RESPONSE TO REQUEST FOR ADDITIONAL INFORMATION

APR1400 Design Certification

Docket No. 52-046

RAI No.: 519-8687
SRP Section: 06.02.02 - Containment Heat Removal Systems
Application Section: 6.2.2
Date of RAI Issue: 09/11/2016

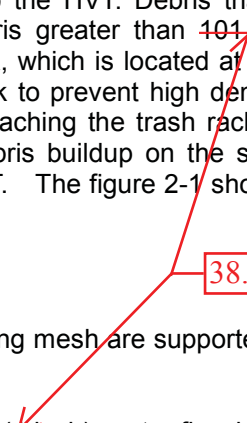
Technical Report APR1400-E-N-NR-14001-P, Rev. 0, "Design Features to Address GSI-191," Section 2.3 states that the HVT trash racks prevent debris particles larger than 1.5 inch from entering the HVT. However, Technical Report APR1400-E-N-NR-14002-NP, Rev.0, "IRWST Sump Strainer and Trash Rack Structural Analysis," Section 2.1 states that debris greater than 4 inch diameter is prevented from entering the HVT by a vertical trash rack and Section 2.2 states that the trash rack is designed to prevent debris larger than 4 inch. These two technical reports appear to inconsistently describe the HVT trash rack mesh size as both 1.5 inch and 4 inch. The applicant is requested to specify the HVT trash rack mesh size and to revise the technical reports as applicable to consistently describe the HVT trash rack mesh size.

As the trash rack is designed to prevent debris larger than ~~101.6 mm (4 inch)~~, water flow blockage will not happen even though the grating mesh is blocked by debris. Therefore the hydraulic-pressure load due to blockage will be negligible. But the trash rack is designed to resist the hydraulic pressure load of 2.3 m (90.5 in) water depth assuming hydraulic water pressure buildup due to grating mesh blockage. In addition, the trash rack is designed considering seismic load due to self weight excitation of grating mesh. But, the seismic load is negligible since the self-weight of grating mesh is very small compared to the assumed hydraulic pressure load.

The HVT trash racks prevent debris particles larger than 1.5 inch from entering the HVT because the HVT trash rack mesh size is 1.5 inch. Technical Report APR1400-E-N-NR-14002-NP, Rev.0, Section 2.1 and Section 2.2 will be revised to be consistent with Technical Report APR1400-E-N-NR-14001-P, Rev. 0.

38.1 mm (1.5 inch)
